WET AREAS

SUPPLEMENT

October 2016 Update

LEVEL SUSTAINABLE BUILDING SERIES

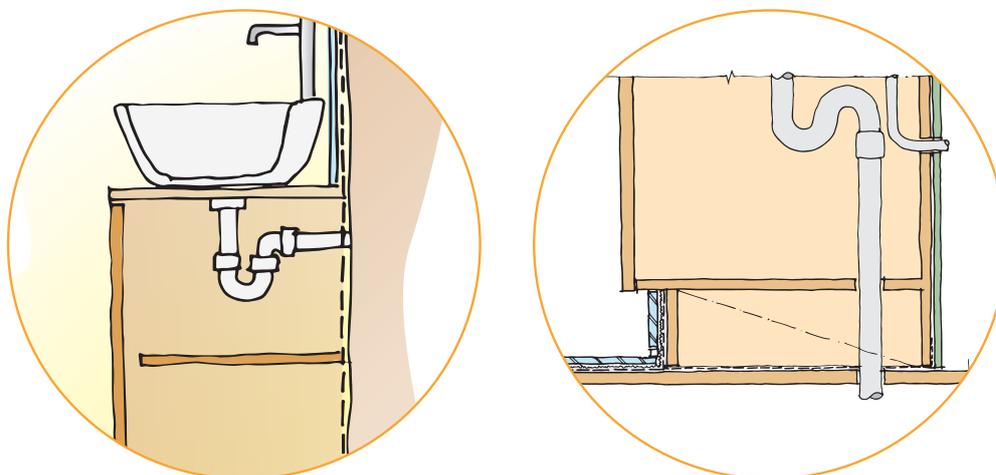
In Figure 24, it is common construction practice today to put the wastepipe through the floor after the U-bend:
